ADDENDUM NO. 2

DATE: March 26, 2019
FROM: City of Grand Junction Purchasing Division
TO: All Offerors
RE: The Riverfront at Dos Rios Business Park Phase I IFB-4616-19-DH

THE RIVERFRONT AT DOS RIOS
STORM DRAIN PLAN AND PROFILE

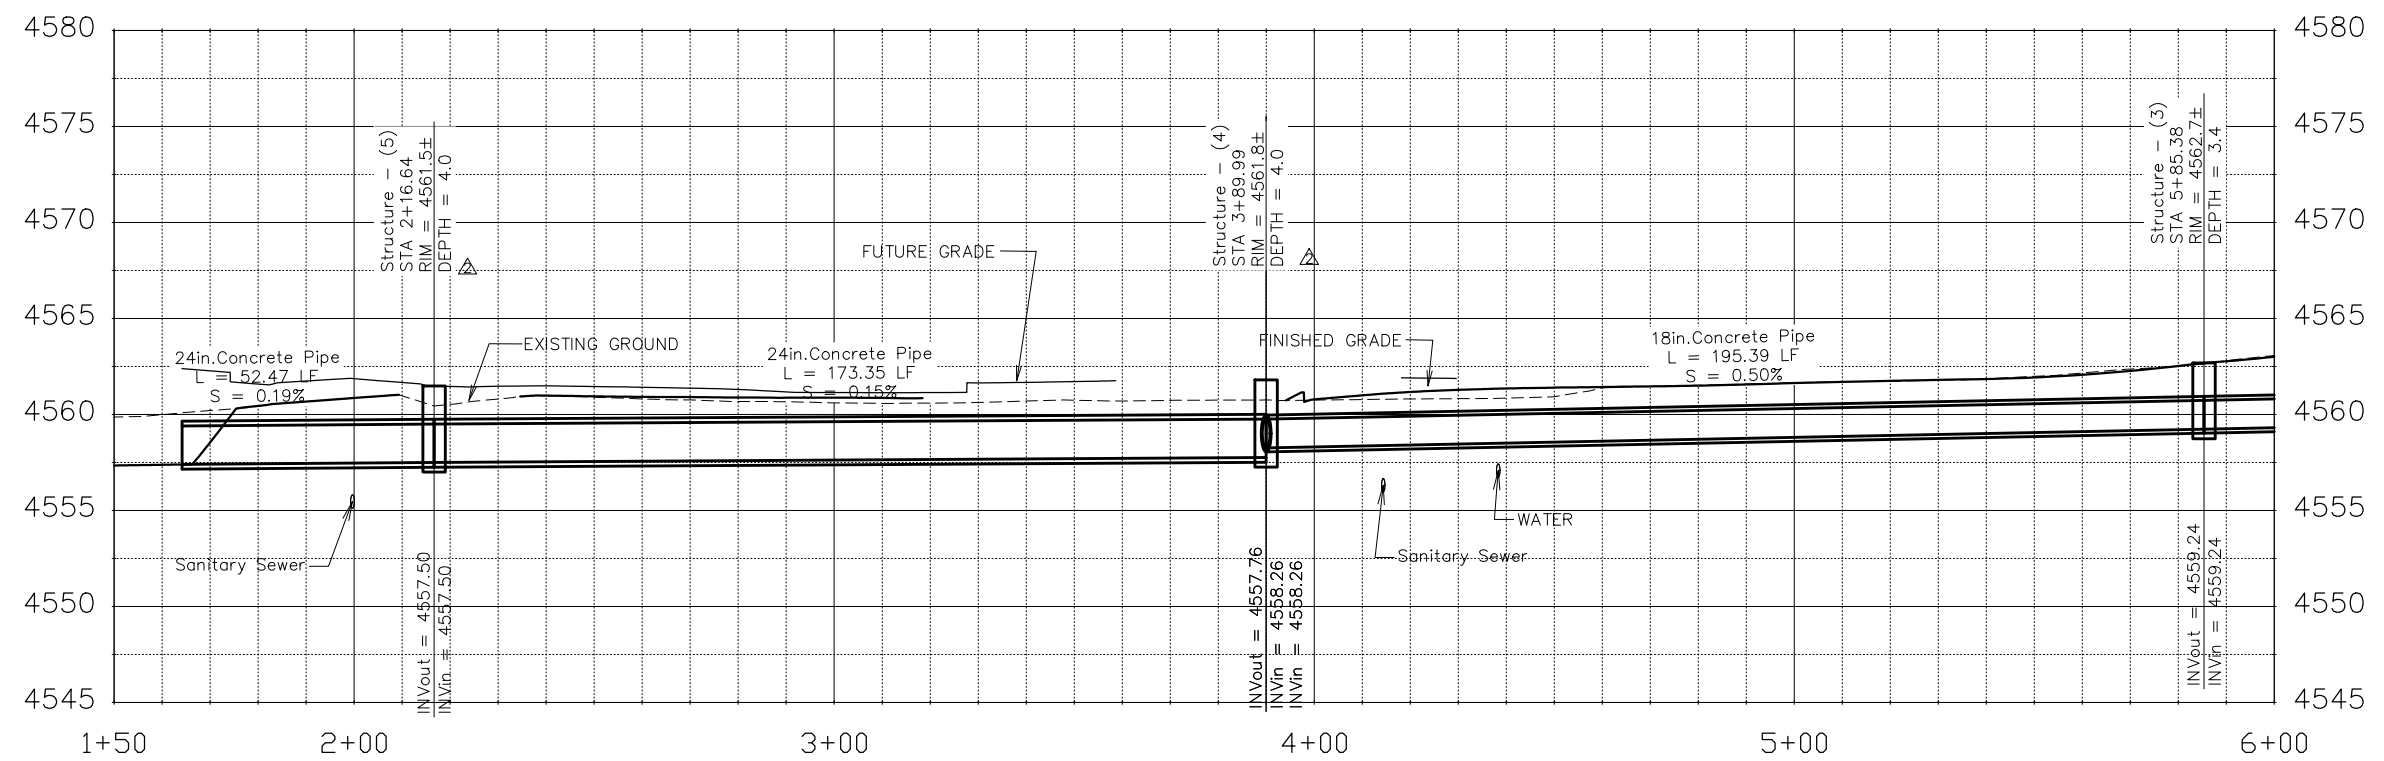
3. Q3. Storm manholes #4 & #5 on the plan view page 10 are called 48" Dia. on a 24" line, but your standards call for 60" Dia. manholes, which the bid schedule is correct.

4. Q4. here are the shop drawings for the 2 ea. 60" Dia. storm manholes, showing that they are too shallow to work. Please advise.

REVISION	DESCRIPTION	DATE
REVISION Δ	ADJUST STORM MH SIZE & DEPTH	3-25-19
REVISION Δ		
REVISION Δ		
REVISION Δ

A3. Storm manholes #4 & #5 shall both be 60" in diameter.

A4. The finished grade rim elevation for Storm manholes #4 & #5 have been updated to account for the shallow depth. See the attached updated Construction Plan sheets.

THE RIVERFRONT AT DOS RIOS
SANITARY SEWER PLAN AND PROFILE

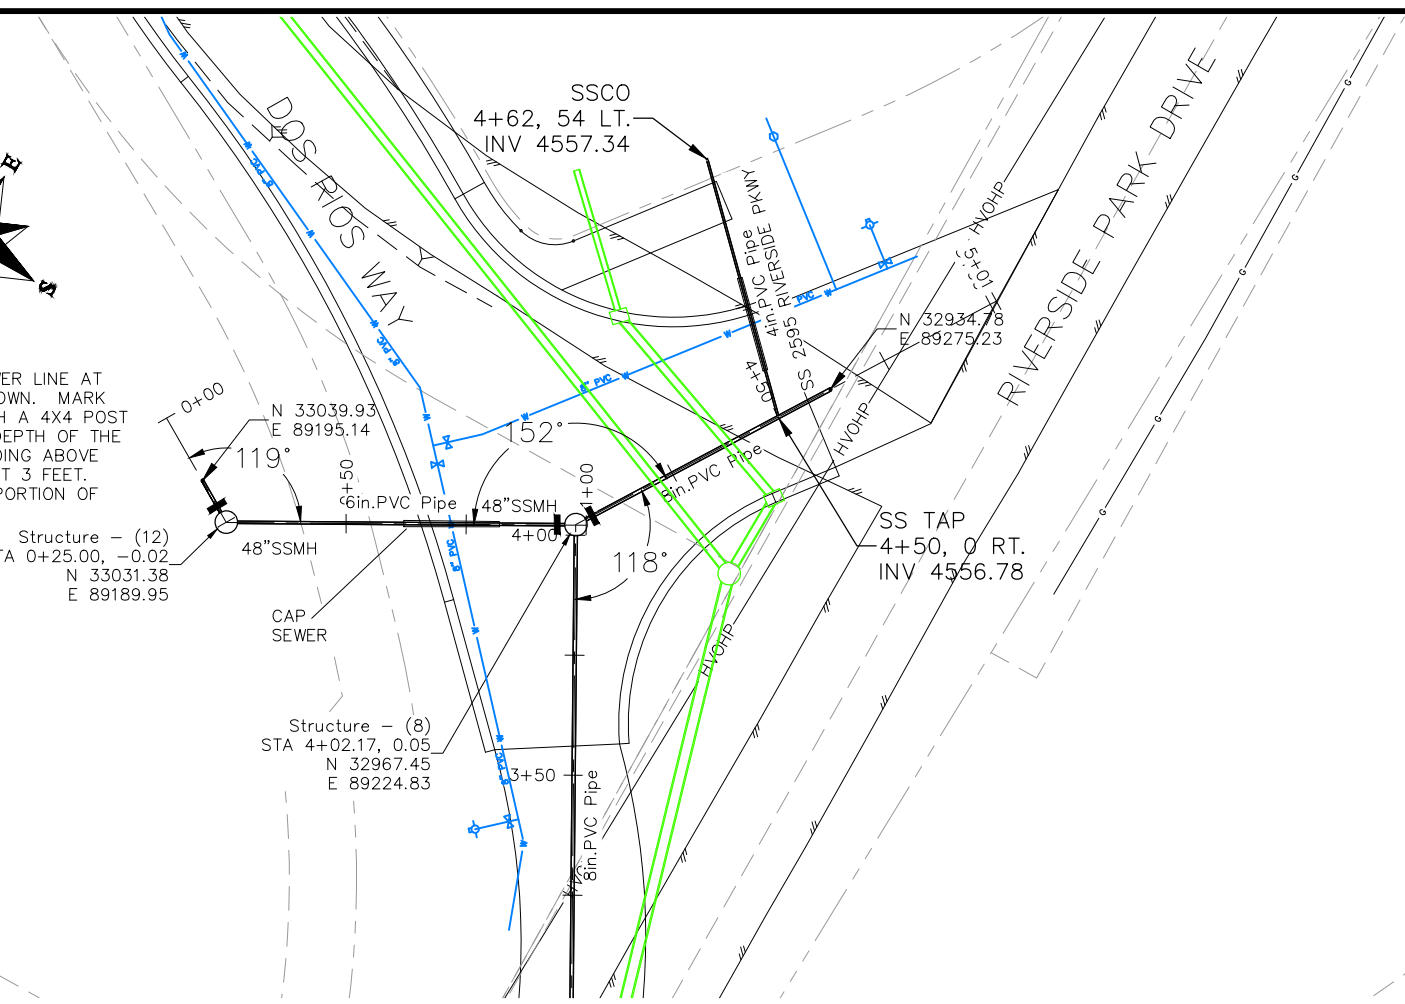
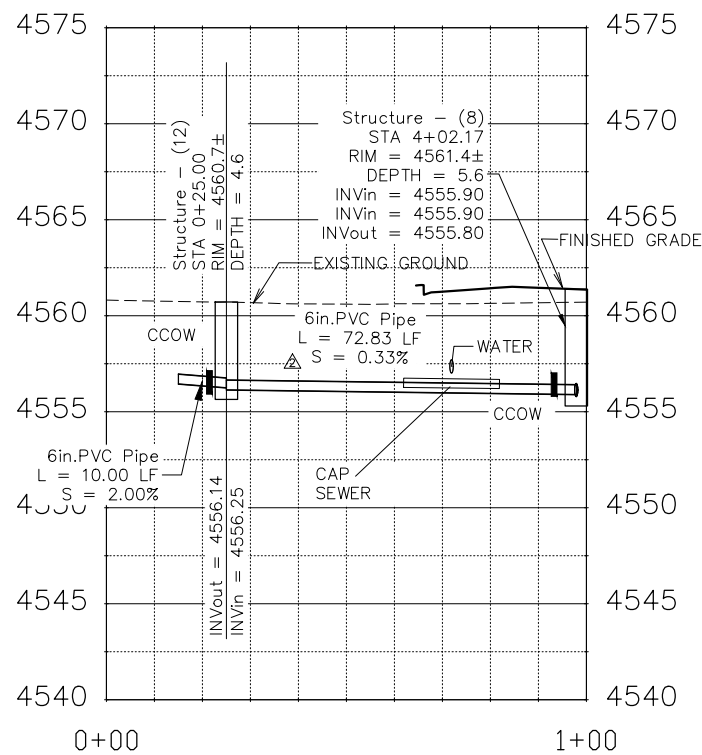
1. Q1. Sanitary manhole #11 should be 60" Dia. due to the 21" Dia. existing sanitary line?

2. Q2. Sanitary Manholes #10 thru #8 have NO fall thru the manholes, will you allow a precast invert in these manholes?

REVISION	DESCRIPTION	DATE
REVISION △	SEWER SERVICE SIZE CLARIFICATION	3/14/19
REVISION △	SEWER PIPE GRADE ADJUSTMENT	3/20/19
REVISION △		
REVISION △

A1. Sanitary manhole #11 has been updated to a 60" Dia. manhole. See the attached updated Construction Plan sheets.

A2. Sanitary manhole(s) #10 thru #8 have been updated to account for fall across the manholes. See the attached updated Construction Plan sheets.
